- ☐ Concept Design Review
☒ Detail Design Review

DRB Meeting Date: September 24, 2020

MULTI-FAMILY RESIDENTIAL
Chapter 18.170

DETAIL DESIGN REVIEW- EAST ELEVATION

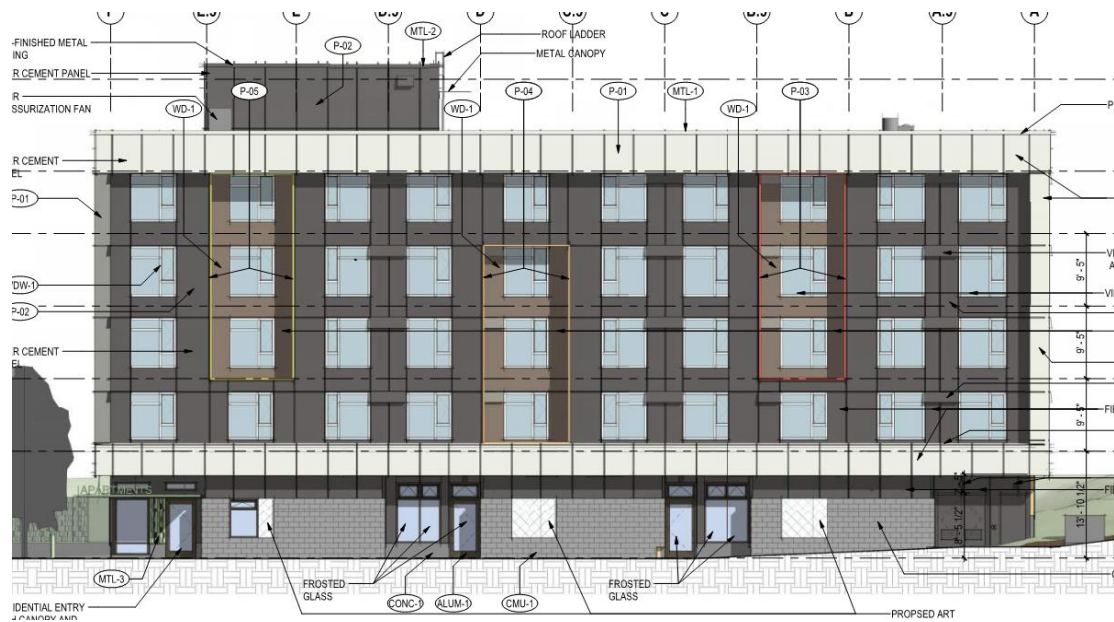
Staff Response: One of the conditions that the Board made at the Conceptual design review meeting asked the applicant to incorporate similar building materials and colors found on the south elevation and wrap around to the east façade. The intent of the Board was to enhance the building facade with a clearly defined entry for the residential entry. The following are the elevation of the east façade at time of conceptual design review and the south and southeast elevation of the proposed plans for detail that show how the project has been modified to meet the condition. Staff find that the revisions adequately address the concern and therefore have not added any further conditions of approval related to this topic.

Detail Design Review- Landscaping on the north boundary

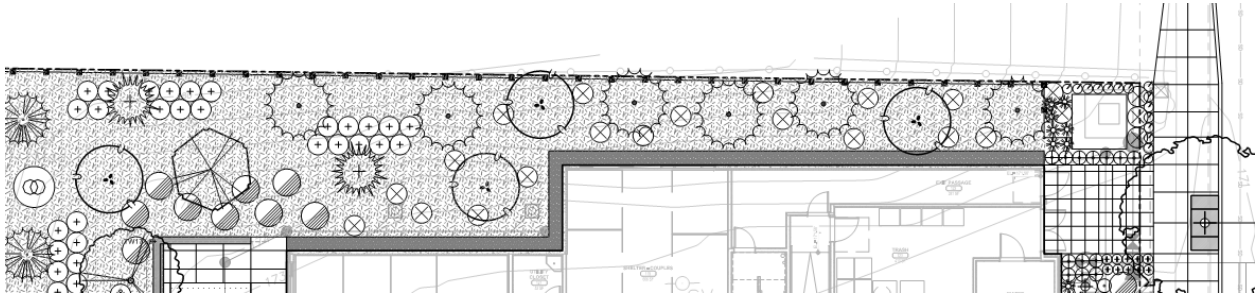
Staff Response: At time of conceptual design review application the Board recommended that the detail design review plans show additional sight obscuring landscape with larger evergreen tree species be provided at the north boundary to improve transition between the project and the adjacent properties. The landscaping plans shows additional evergreen type trees proposed along the north boundary. See conceptual plan and details plans below showing the proposed change. Staff finds that the revision to this perimeter landscaping is adequate that will improve the transitioning between the 5 story building and the adjacent uses to the north.
